**Project Name:** Free Street - 110; Building Renovations; Maine Health, Applicant.  
**Project ID:** 09-79900019  
**Project Address:** 110 FREE STREET

**MAINEHEALTH  
110 FREE STREET BUILDING RENOVATIONS  
APPLICATION FOR MINOR SITE PLAN REVIEW  
CITY OF PORTLAND PLANNING DEPARTMENT  
PORTLAND, MAINE  
Project No. 09146**

Minor Site Plan Review Application

Responses to Review Comments for Final Plan  
Planning Authority Review dated January 14, 2010

Drawing Number  
**C00.1**

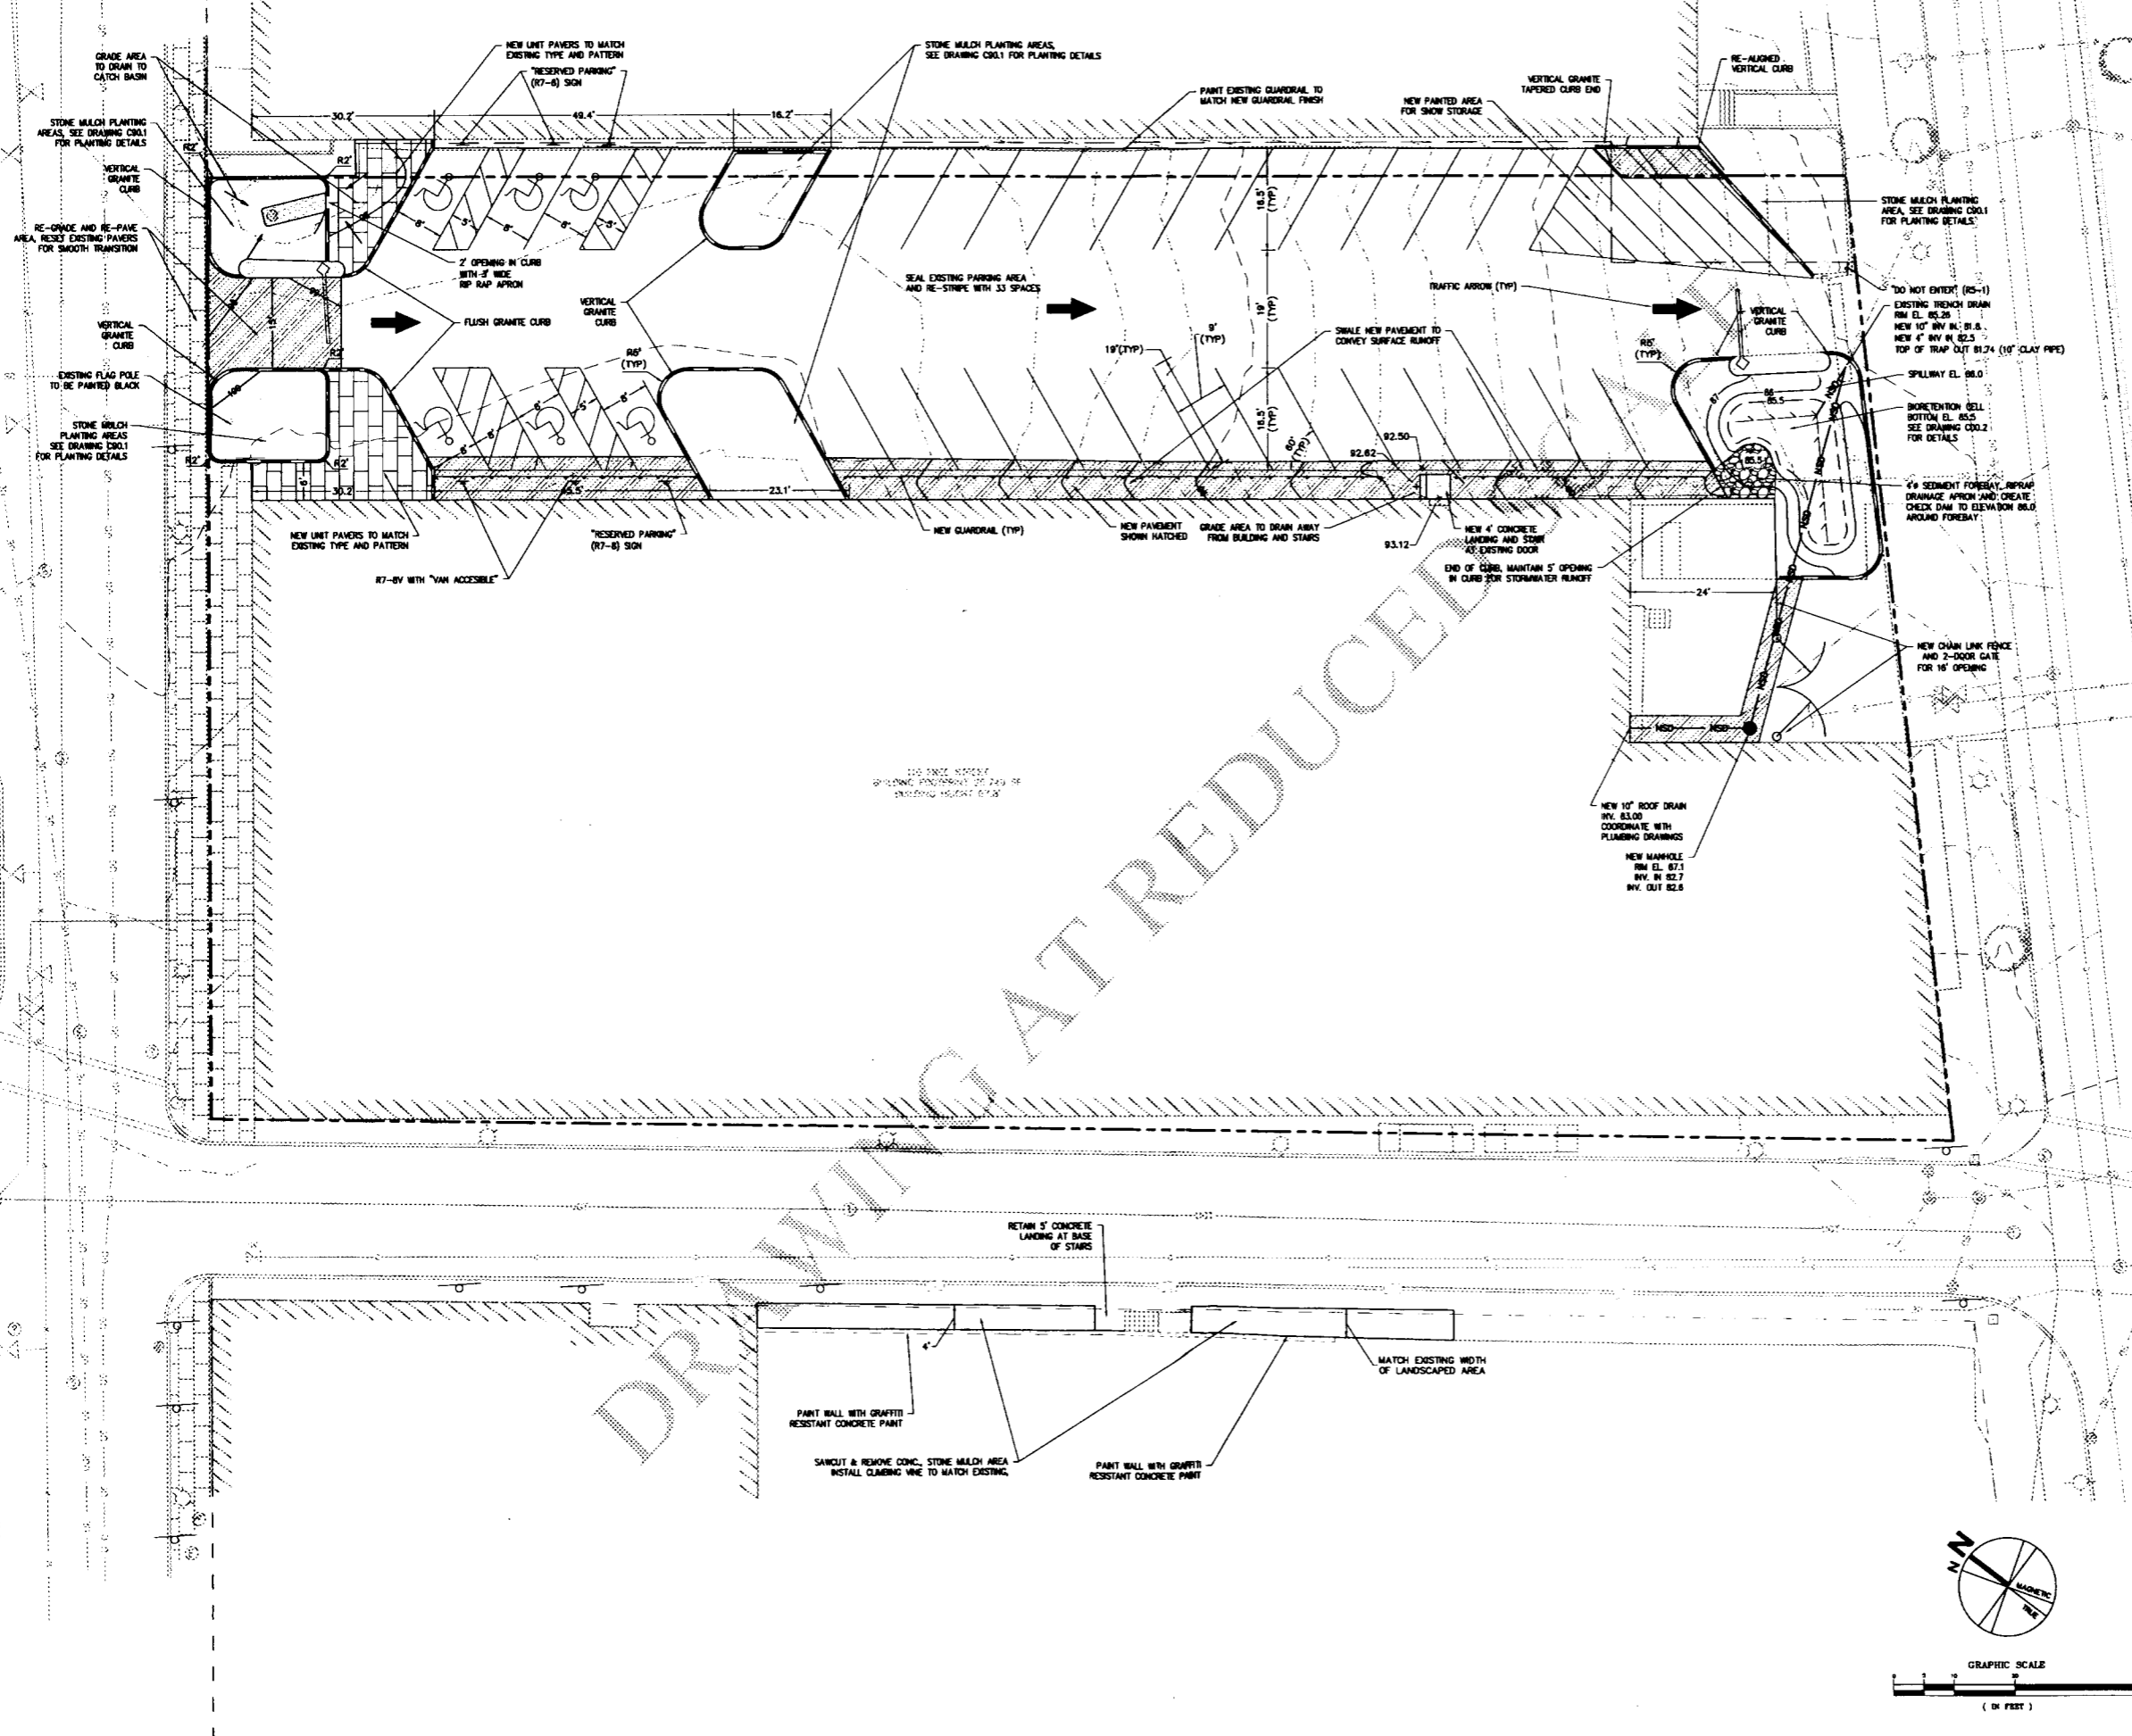
Comment: F. Consulting Engineer: Stormwater Dan Goyette  
1. *The applicant should look into an overlay of the parking surface rather than a seal coat due to the negative environmental impacts from seal coats.*  
2. *In addition, we would recommend the use of a timber guardrail instead of metal.*

Shukria – I have reviewed the submittal dated December 11, 2009 prepared by Harriman Architects and Engineers and find the layout of the proposed 33 space parking lot to be acceptable. During the renovation of the building, it is my assumption that all sidewalks will remain open. If this is not the case, the applicant should provide a plan for sidewalk closures for review and approval.

Response: The scope and budget of the project improvements do not support a bituminous pavement overlay of the entire parking lot. The intended function of the seal coat is to prevent pavement deterioration and allow restriping/reconfiguration of parking stalls. In addition, a portion of the parking area run-off is being treated via bio-retention cell to help mitigate environmental impacts.
